**PCN#20140227000
Green Mold Compound Conversion for LMP7704MT(X)/NOPB
Change Notification / Sample Request**

PCN Number:	20140227000			PCN Date:	02/28/2014
Title:	Green Mold Compound Conversion for LMP7704MT(X)/NOPB				
Customer Contact:	PCN Manager	Phone:	+1(214)480-6037	Dept:	Quality Services
Proposed 1st Ship Date:	06/01/2014	Estimated Sample Availability:	03/01/2014		
Change Type:					
<input type="checkbox"/> Assembly Site	<input type="checkbox"/>	Assembly Process	<input checked="" type="checkbox"/>	Assembly Materials	
<input type="checkbox"/> Design	<input type="checkbox"/>	Electrical Specification	<input type="checkbox"/>	Mechanical Specification	
<input type="checkbox"/> Test Site	<input type="checkbox"/>	Packing/Shipping/Labeling	<input type="checkbox"/>	Test Process	
<input type="checkbox"/> Wafer Bump Site	<input type="checkbox"/>	Wafer Bump Material	<input type="checkbox"/>	Wafer Bump Process	
<input type="checkbox"/> Wafer Fab Site	<input type="checkbox"/>	Wafer Fab Materials	<input type="checkbox"/>	Wafer Fab Process

Sample product shipping label – Matte Sn Finish (not actual product label)

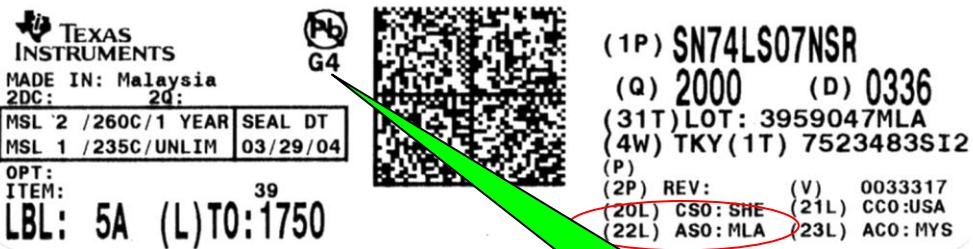
Changes to product identification resulting from this PCN:

Current: e3
Green Conversion: G3
